environmental review team report

Windham

ASHFORD  
AND  
WILLINGTON,  
CONNECTICUT

ENVIRONMENTAL REVIEW TEAM REPORT  
ON  
WINDHAM HILL  
ASHFORD AND WILLINGTON, CONNECTICUT  
NOVEMBER, 1973

WINDHAM HILL  
PRELIMINARY SCHEME OF DEVELOPMENT  
FOR FIRST PHASE

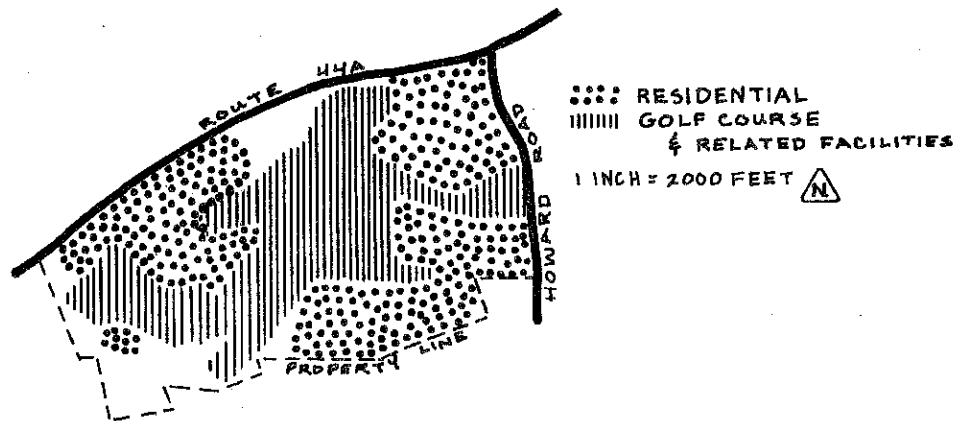
About thirty percent of the soils of the first phase fall under the inland wetlands classification as defined by P.A. 155. The golf course, as proposed, overlaps a substantial portion of this area. Besides the regulatory problems of P.A. 155, the extensive and elaborate drainage system and the fill that would be necessary to establish the golf course present serious questions as to the practicality and economic feasibility of the golf course.

In general, the concept of a combined golf course and residential development appears to be a good one. In this particular case, however, the intensity of development proposed for this site should be reevaluated with respect to its location within a water supply watershed and its relation to substantial wetland areas.

The generation of large amounts of traffic onto Howard Road should be discouraged due to its dangerous intersection with Route 44A. The plan as presently designed indicates that a large number of homes on the Ashford side of the development might be serviced by Howard Road. More convenient access to Route 44A would be preferable.

It does not appear practical or economically feasible to install a golf course as now proposed. A substantial portion of the golf course is located on poorly or very poorly drained soils that are designated as inland wetlands under P.A. 155. To develop a golf course that skirts a wetland could be both feasible and practical, but to develop a golf course through a wetland presents severe drainage and runoff problems that would be costly to correct. It should also be noted that fill over the wetland would also quickly become saturated unless the area is under-drained correctly.
